RC245088

s92 - Request for Further Information and Affected Party Approval

I have reviewed the resource consent application **RC245088** by Woolworths New Zealand Limited to establish and operate a supermarket and small-scale ancillary retail tenancies, including associated earthworks, access, carparking, signage and landscaping at 597 East Maddisons Road, Rolleston. More information is needed so that I can better understand your proposal and its potential effects.

**RE: Woolworths Rolleston
Selwyn District Council RFI Transport Responses**

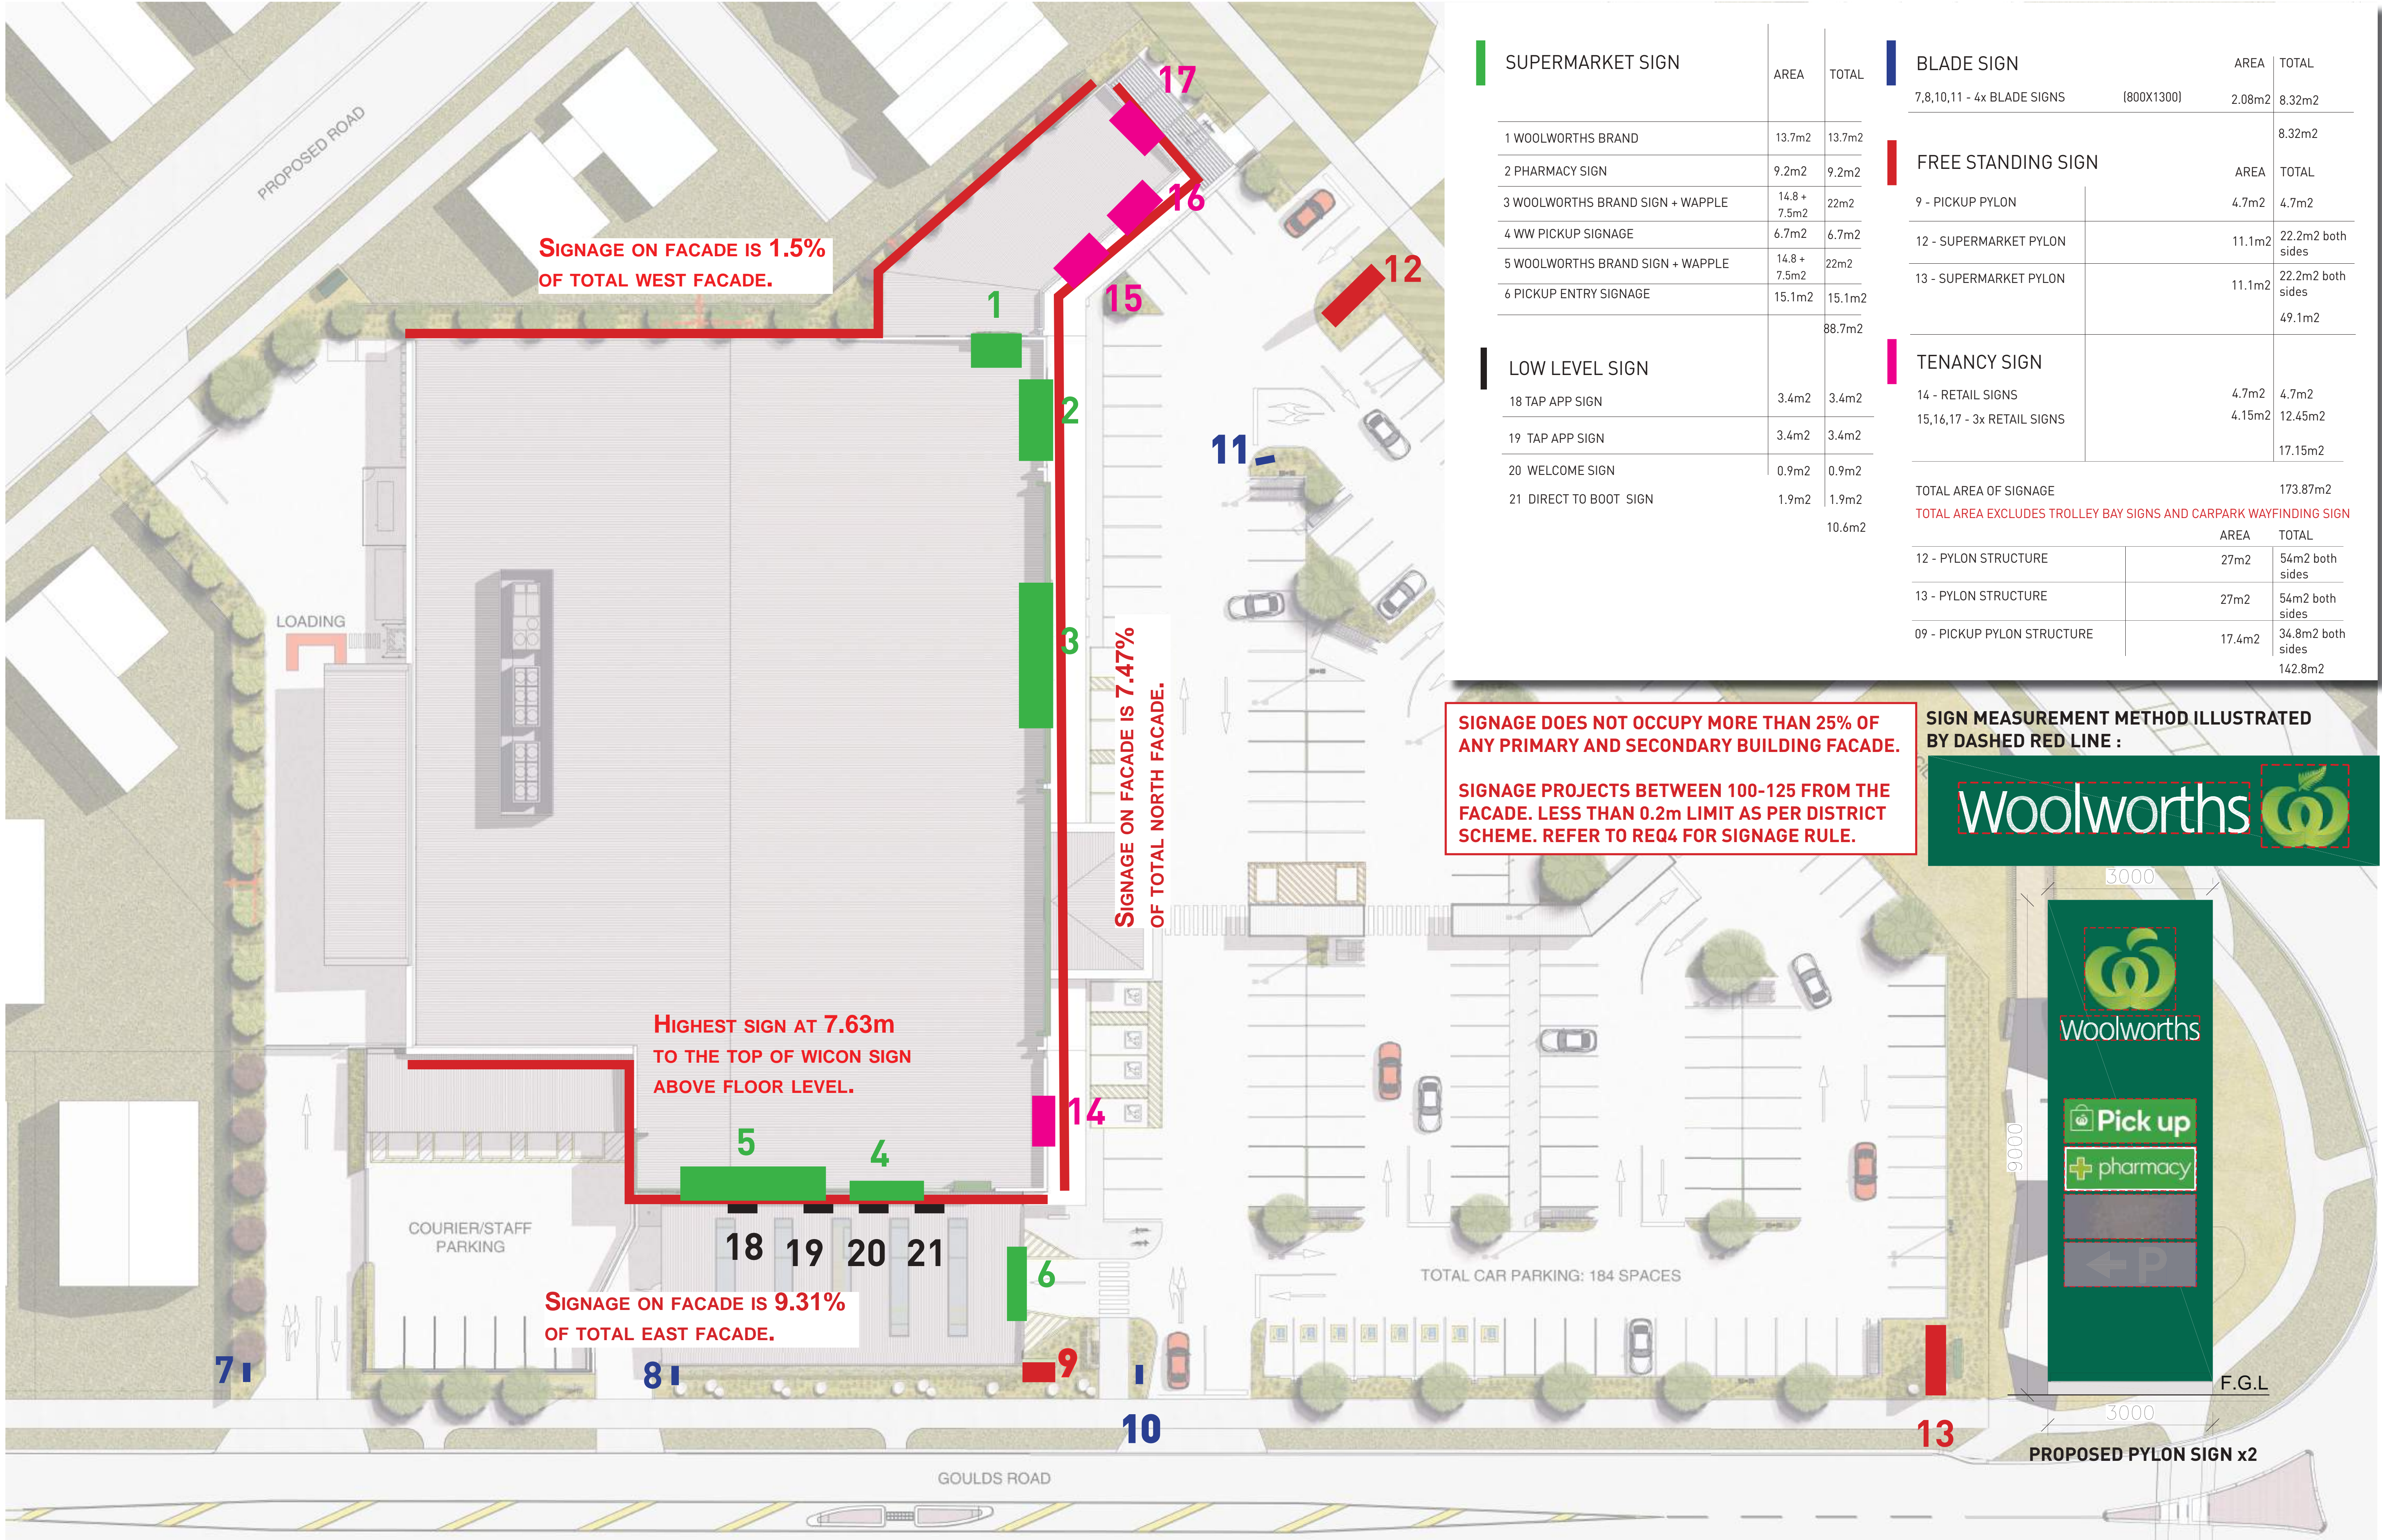
6. Thank you for the detailed assessment of the proposal against relevant Partially Operative Plan (PODP) standards. However, the assessment provided for signage has been undertaken on a cumulative basis for the surface area of all signs. The PODP sign standards (both for free-standing and attached signs) is based on the surface area of each individual sign. As such, can you please provide an amended assessment that details the surface area for each sign.
7. In addition, please provide amend the assessment to include SIGN-R1/SIGN-REQ4 (Built Form – Signs Projecting from the Face of a Building). This includes the maximum projection of each sign from building facades.
8. Lastly, please confirm the overall number of signs proposed. The figure given in the AEE and Appendix L (PODP assessment) currently differ.

5. The attached plan set includes a schedule of proposed signs on sheet RC-10 and provides the area of each individual sign. As noted on the plan notation signs attached to the building and parallel with the façade will not project more than 0.2m from the façade.

Figure 3: Visibility to Shared Path at Goulds Road Car Park Access Point

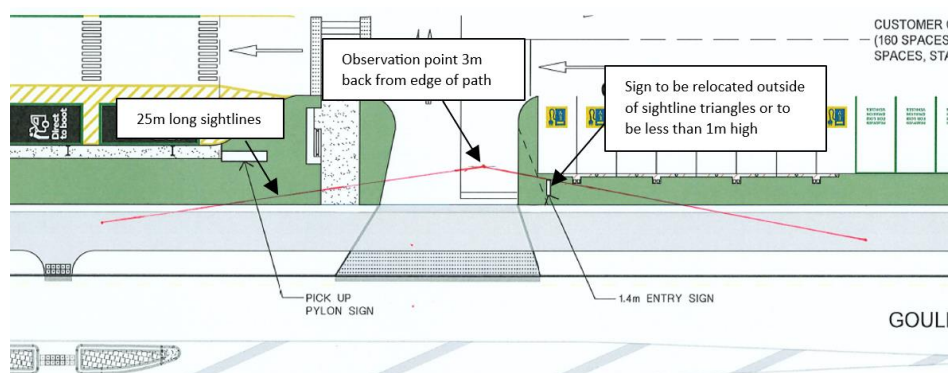
Request 10: *The proposed Shillingford Boulevard and Goulds Road accesses will lead to vehicles crossing shared paths. Please detail what measures have been considered to ensure drivers are aware of pedestrians and cyclists on these routes, including reference to:*

The below shows 25m sightlines from the Goulds Road car park access point. As described in the ITA, the separation from the road boundary to the car parking spaces means that visibility for exiting drivers will be available along the shared path. The 'entry sign' will need to be either relocated outside of the sightline triangles or made lower than 1m in height so it does not obstruct visibility. Any vegetation within the sightline triangles will need to be kept low. A 2m x 5m pedestrian visibility splay is indicated by the dashed line.

Figure 7: 99th Percentile Car Right Turn In from Shillingford Boulevard

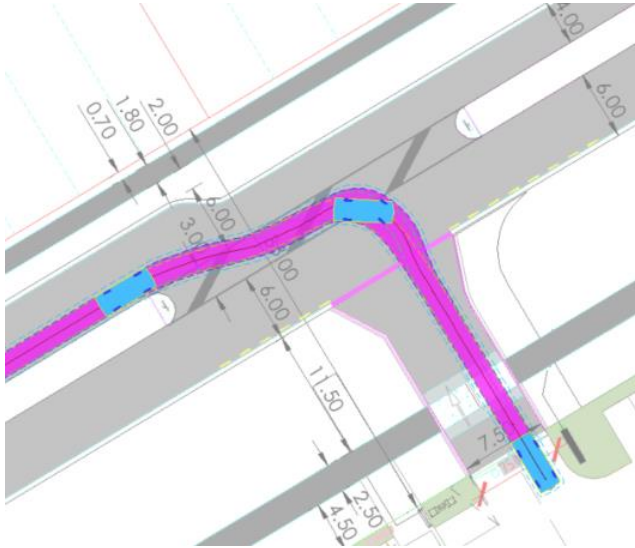
Request 16: *The Shillingford Boulevard access includes a break in the median to accommodate traffic turning right into and out of the site. Please confirm what the predicted queue length is for vehicles turning right into the site is. Furthermore please provide vehicle tracking to confirm that vehicles (turning right into the site) are able to satisfactorily enter this right turn bay and not block following vehicles on Shillingford Boulevard. The tracking must be based on:*

Stantec Response: The tracking below shows a 99th percentile car making a right turn into the site using the break in the median approaching at 20km/h. There would be more than enough space for this vehicle to wait within the median break. It is estimated that in practice there will be space for at least two vehicles to queue making slower speed manoeuvres. The right turn in movement in this location will be a low volume movement, with the traffic modelling presented in the ITA only showing 13vph turning right into the site here during the weekday evening peak. With the moderate through volumes expected on Shillingford Boulevard in the long term, there will be minimal delays or queuing associated with the right turn entry movement (evening peak average delay of 2s reported from traffic modelling).

The right turn entry movement by loading vehicles will be a very low volume movement, if there are any loading vehicles making the movement at all. It is considered appropriate on this road if such a vehicle obstructs following through traffic, noting that any delays for the right turn entry movement will be only momentary.

Figure 8: 23m Truck and Trailer Movements Through Movements at Goulds Road / Shillingford Boulevard Roundabout

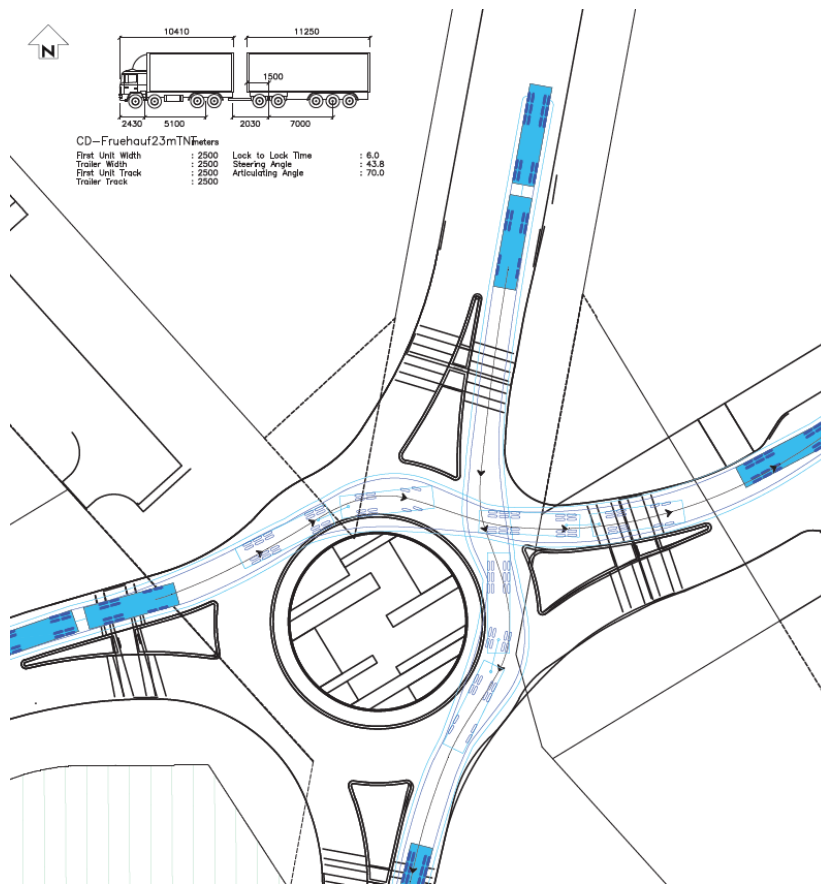
Request 18: *Comments are made that the recently constructed Shillingford Boulevard / Goulds Road roundabout will be able to accommodate the semi-trailer tracking. Please provide vehicle tracking to confirm that assessment.*

Stantec Response: The vehicle tracking in the two figures below shows a 23m truck and trailer making various movements through the roundabout with appropriate clearances to kerbs and islands.

Figure 10: Comments on Potential Bus Stop Locations on Shillingford Boulevard

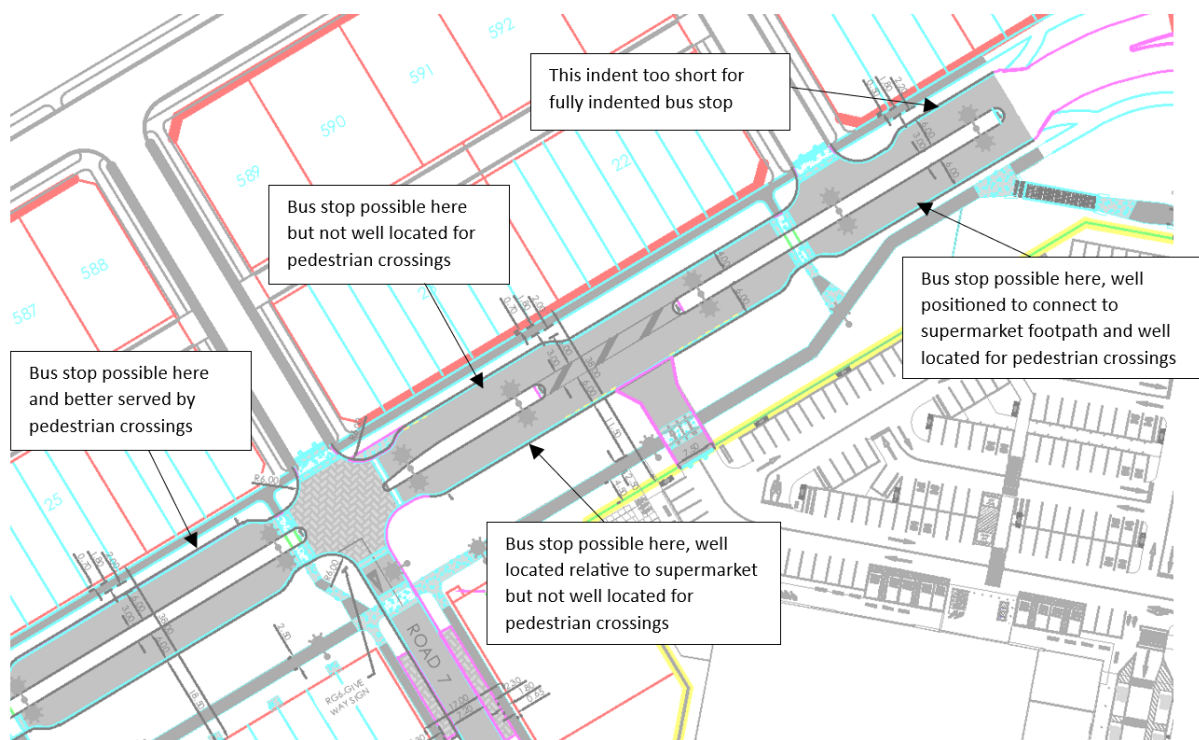
Request 22: With regards to passenger transport, Council has requested that a bus bay be provided on Shillingford Boulevard. Please confirm whether this can be provided for within the proposed layout of Shillingford Boulevard (potentially linking to the footpath connection through the car park)?

Stantec Response: The 6m width being provided between the median island and the kerbs will be sufficient to accommodate bus stops clear of the traffic lane. The below highlights where a bus stop for westbound buses could be provided on the supermarket frontage, with consideration of pedestrian crossing provision. For eastbound buses, the bus stop may need to be west of the supermarket site so that it is served by pedestrian crossing points. It is noted that footpaths are proposed set back from kerbs so some localised changes would be necessary if bus stops are to be provided. This is considered a matter for the design of the subdivision roading and given the roading detailed designs have been lodged with SDC for approval recently, this ideally will be addressed through that process.
